SPF WATER ENGINEERING

MEMORANDUM

RE: *Response to IDWR Staff Memo regarding the sufficiency of water supply for water right applications and transfers along the I-84 corridor*

Figure 1. Cinder Cone CGWA Well Hydrographs

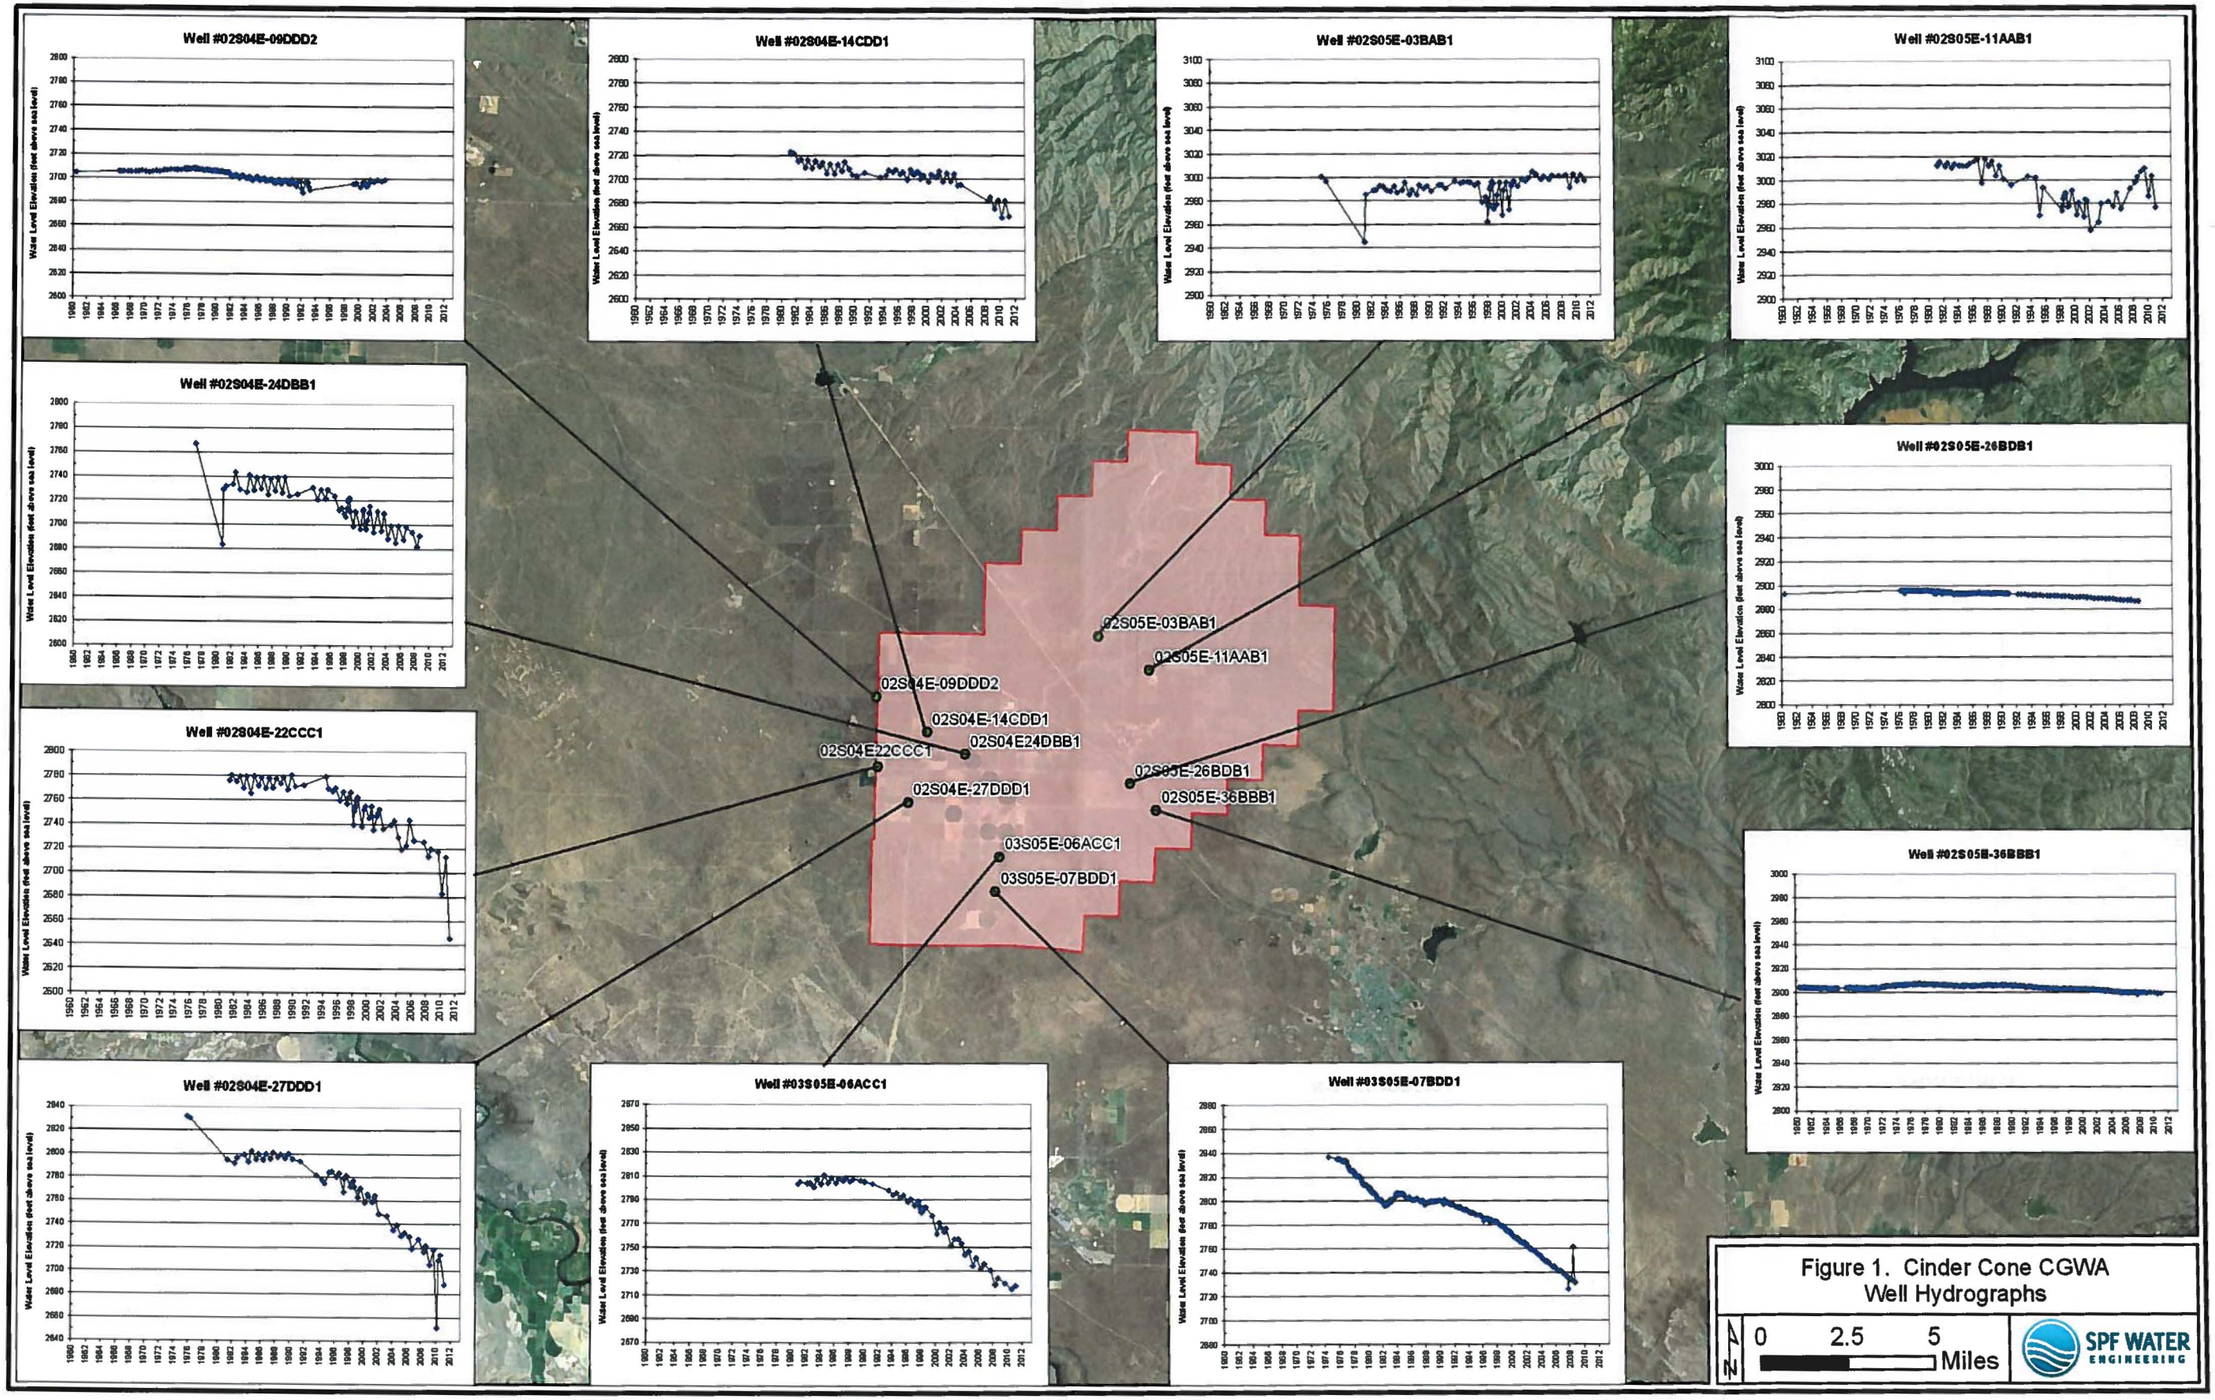
8. The Staff Memo[11] presents hydrographs for the Cinder Cone Butte CGWA. A number of the hydrographs indicate similar downward trends. However, when re-

plotted with consistent y-scales the hydrographs show that the area of greatest declines is limited to the southern portion of the CGWA (Figure 1, page 15).
